Application Number: SSI 7485

Application Name: WestConnex M4-M5 Link

**application number SSI 7485 – WestConnex M4-M5 Link**

The EIS states in 6.5.8 Darley Road civil and tunnel site (C4) that:

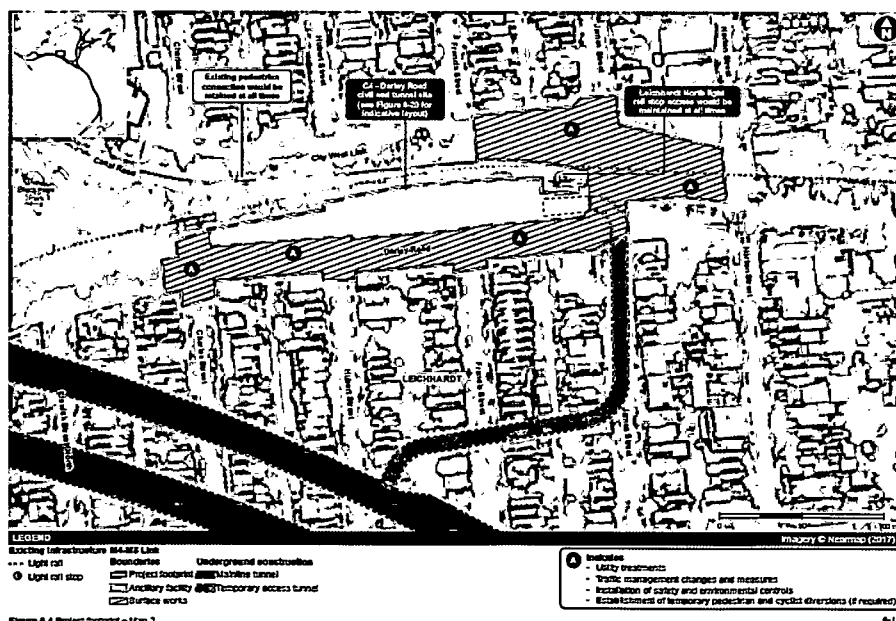
1. I object to the EIS because it fails to describe the temporary changes to Darley Road, Leichhardt to enable access to and from the ancillary facility that would likely be required in relation to the Darley Rd site and instead allows for the final plan to be decided by the contractor.

'Temporary changes to Darley Road to enable access to and from the ancillary facility would likely be required. These may include changes to line marking to provide a temporary turning lane for construction traffic and temporary diversions to the pedestrian path on the northern side of Darley Road. These would be confirmed during detailed design following the appointment of a design and construction contractor and in consideration of the safety and function of the road network, maintaining access to the Leichhardt North light rail stop and providing for continued pedestrian and cyclist movement.'

It is not clear how continued access, pedestrian and cyclist movement will be preserved and I am concerned that the impacts have not been correctly identified and assessed by the proponent.
